ADDENDUM NO. 2

June 27, 2022

Additions and Renovations to Edgewood Intermediate School
7620 E Edgewood Ave.
Indianapolis, IN, 46239

Addendum Two (AD.02) to the drawings and specifications prepared by Gibraltar Design and The Skillman Corporation for **Edgewood Intermediate School Additions and Renovations** for Franklin Township Community School Corporation, Indianapolis, Indiana.

© GIBRALTAR DESIGN SHEET
A-201

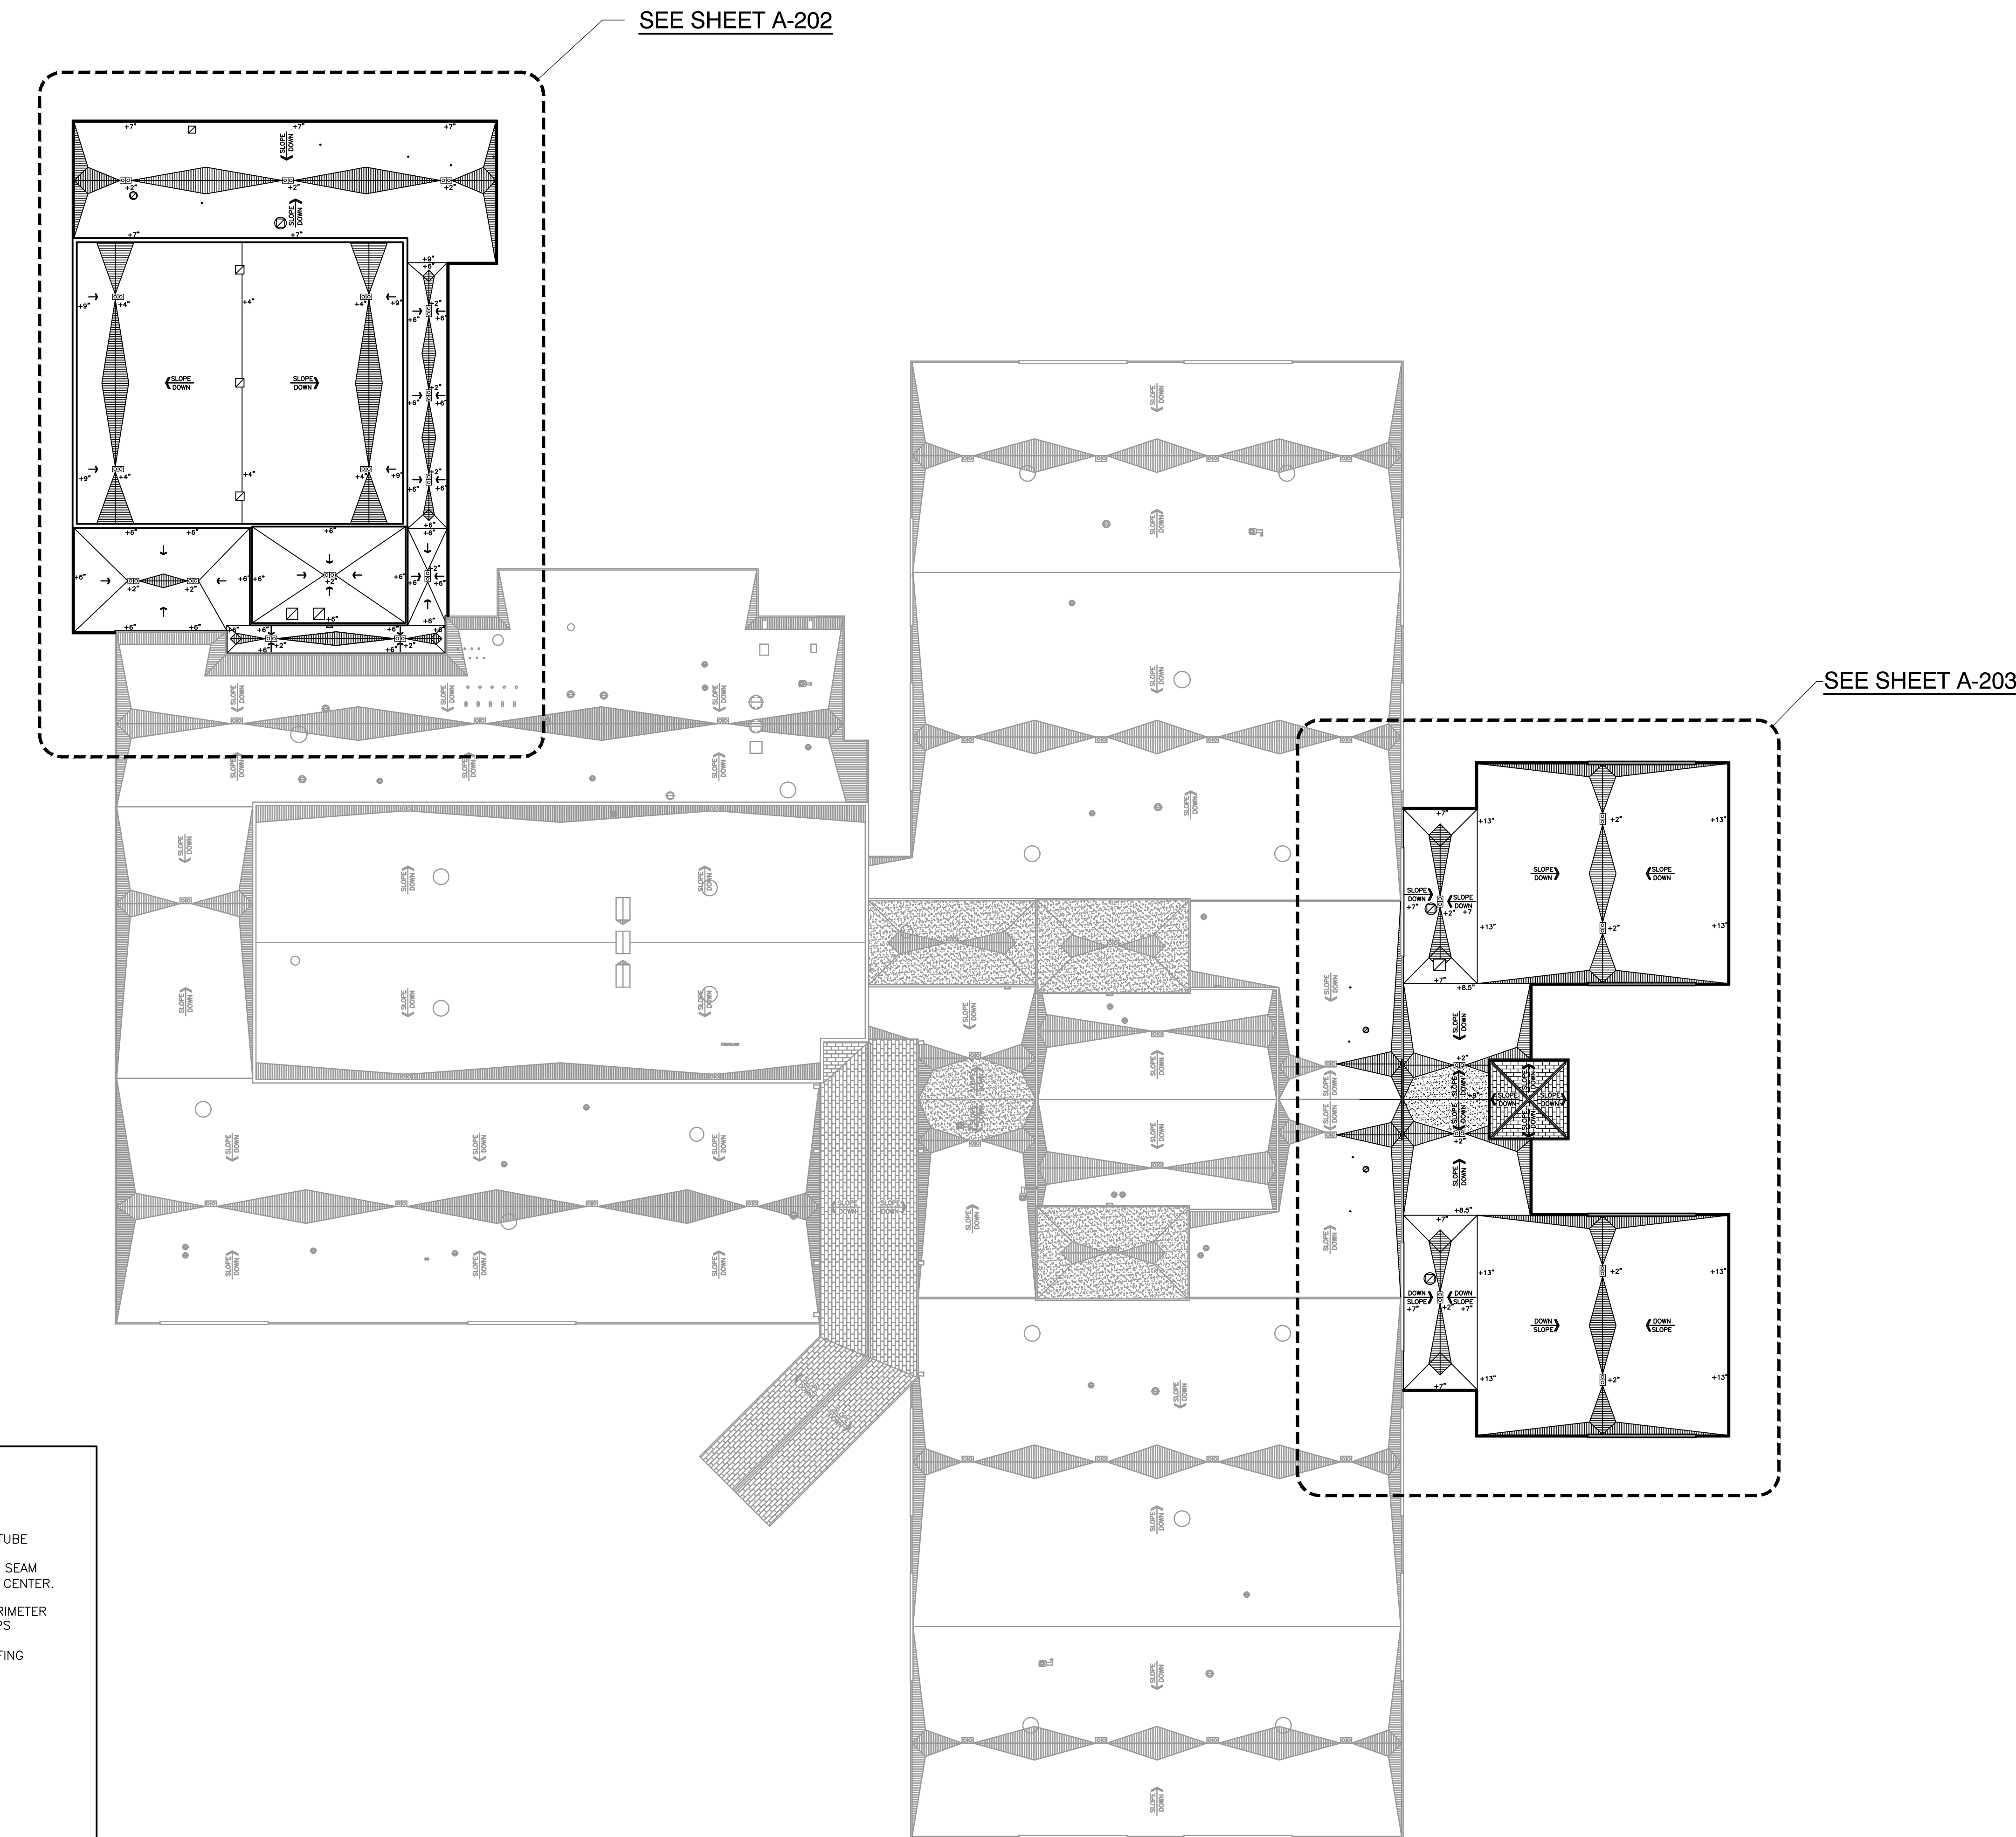
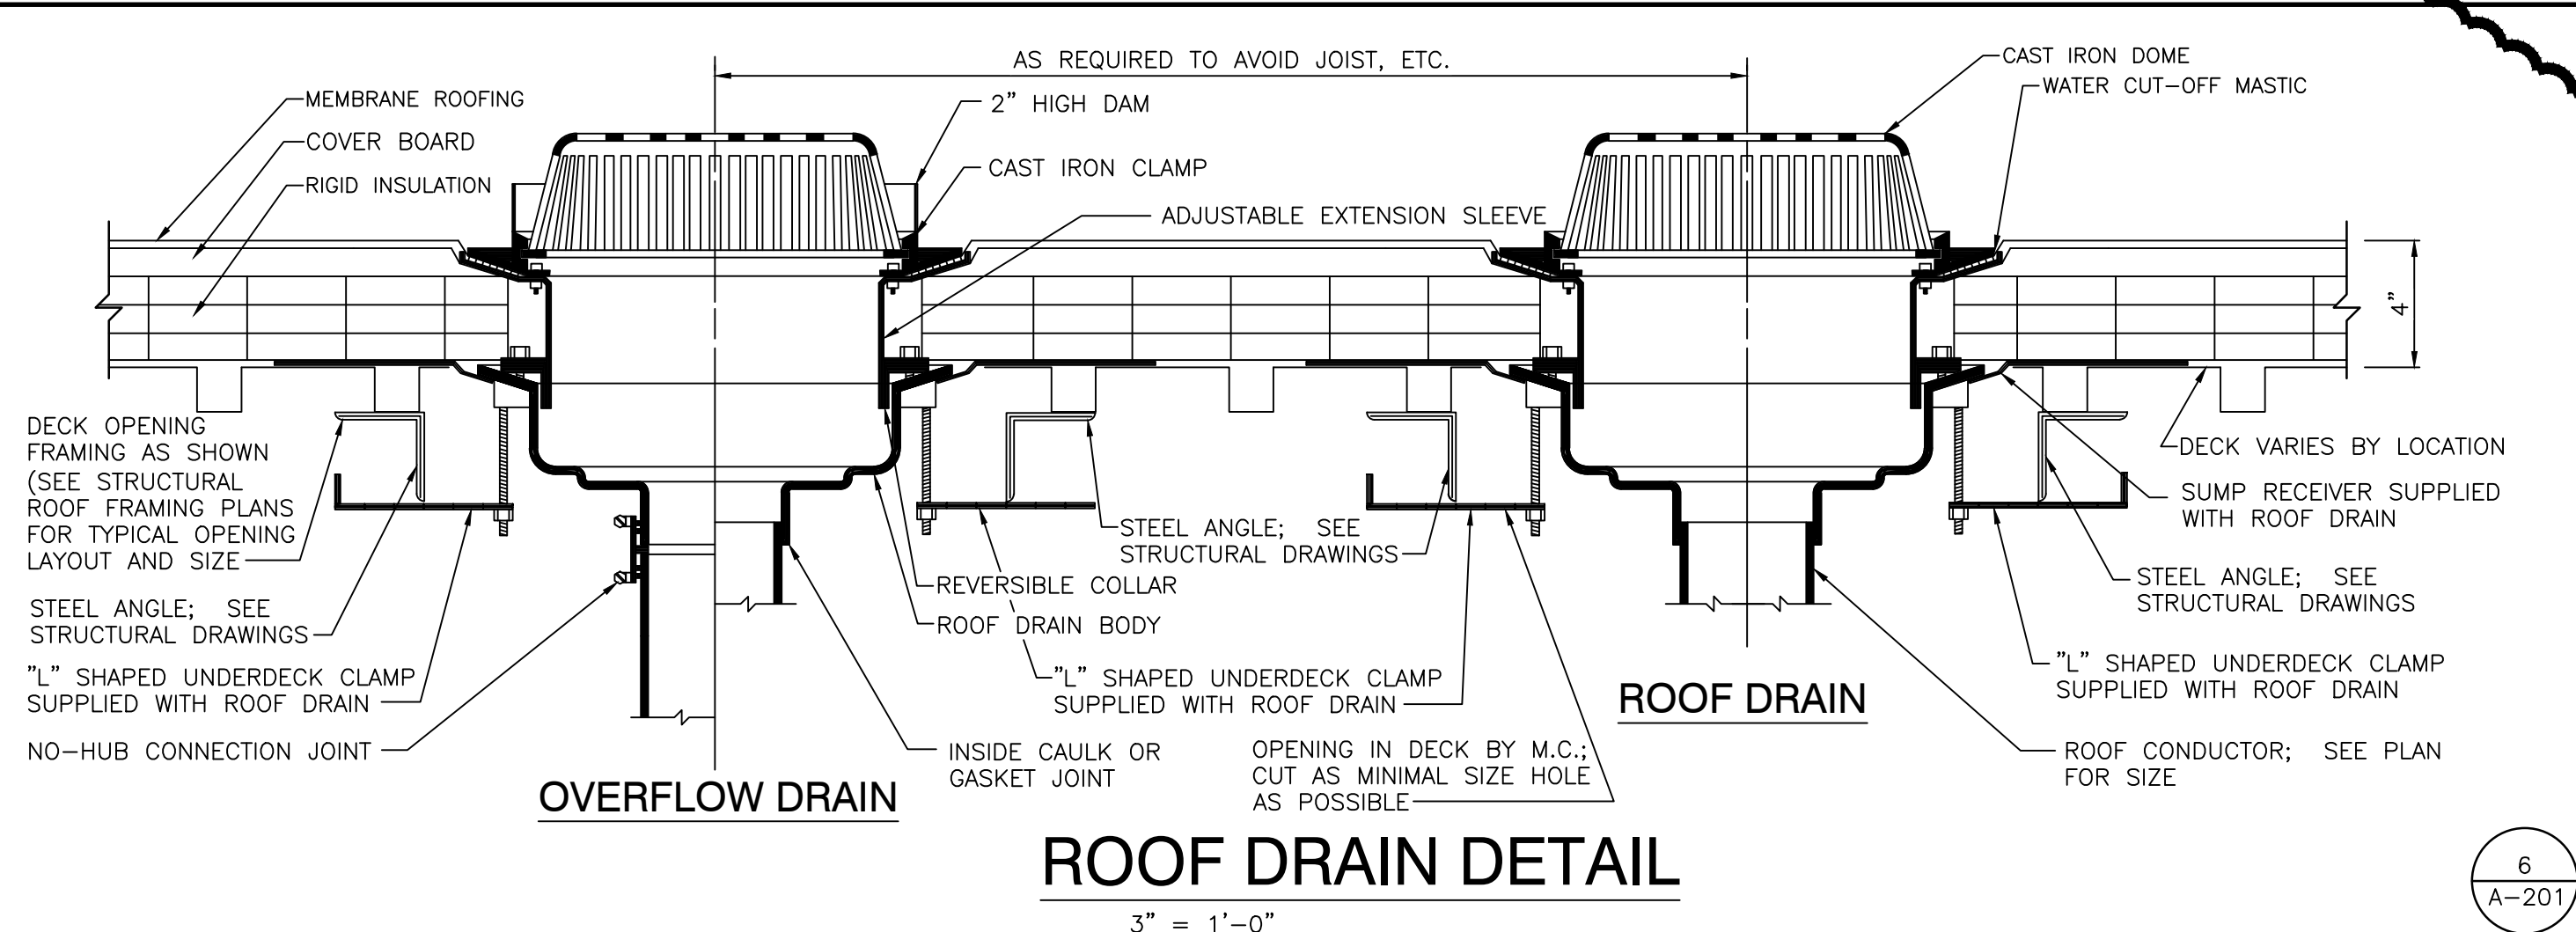
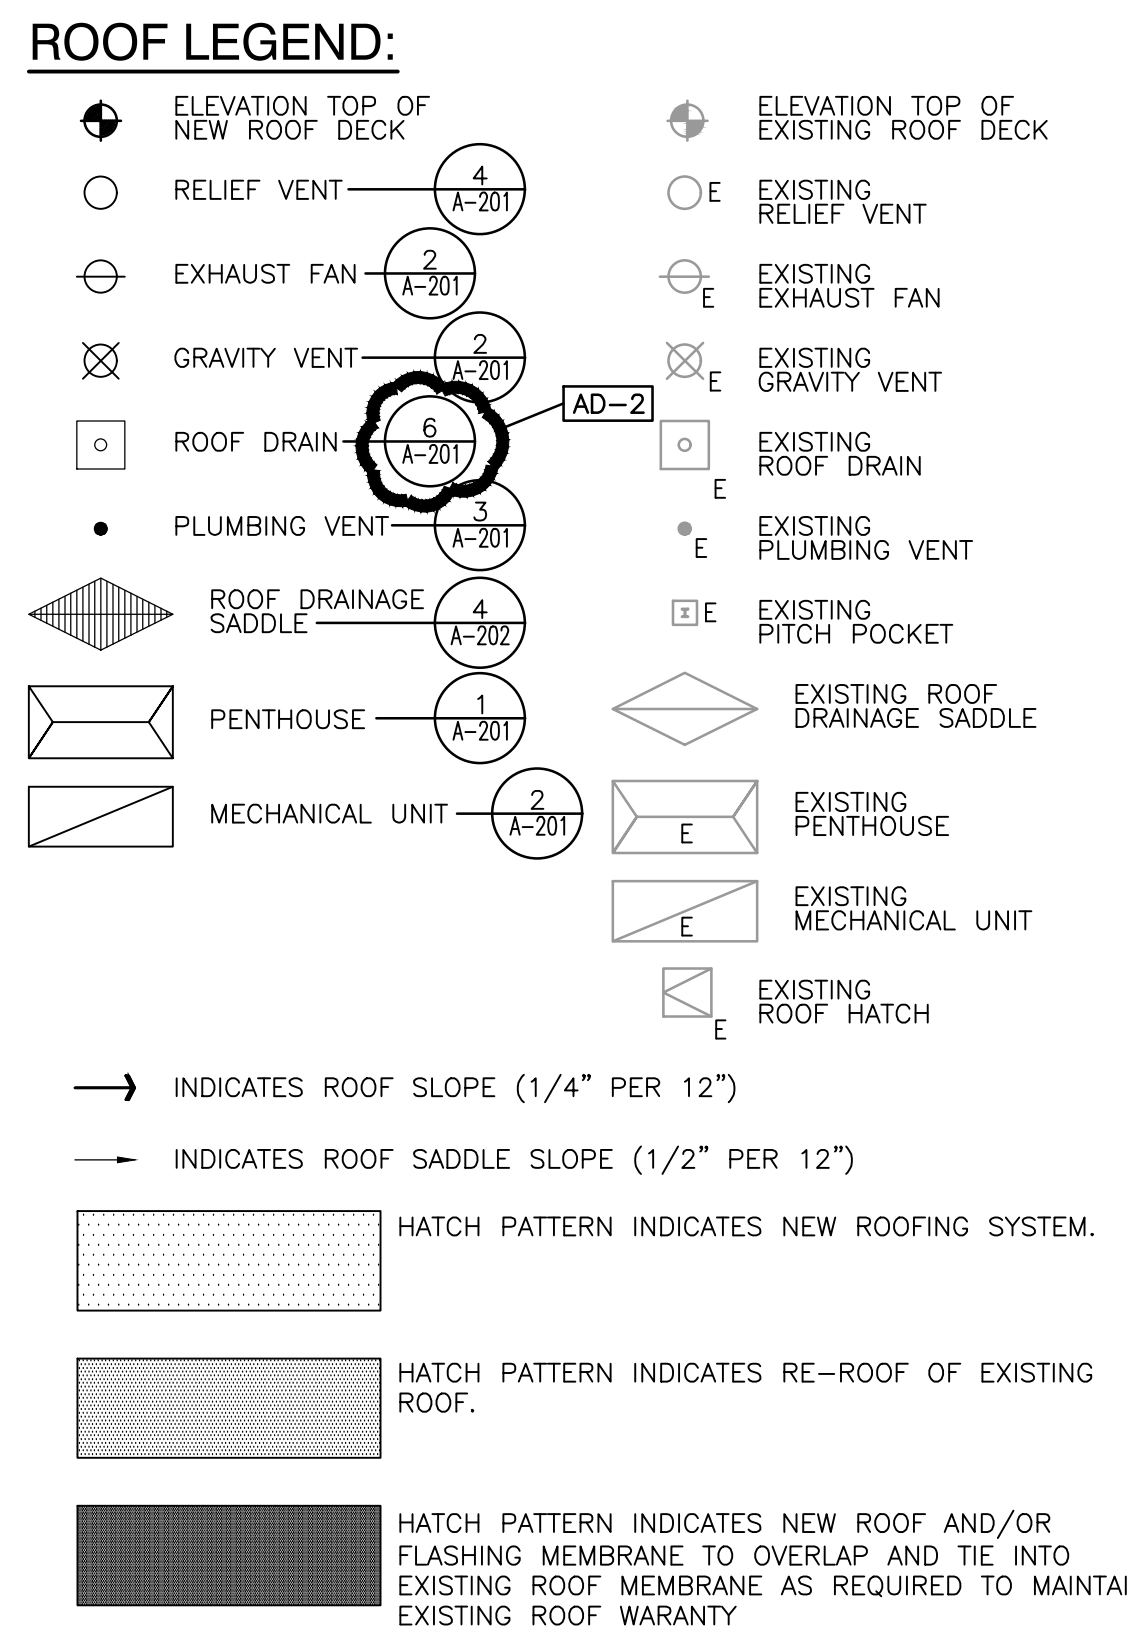
- A. Refer to three (3) revised, full-size drawings, included in this Addendum, for revisions.
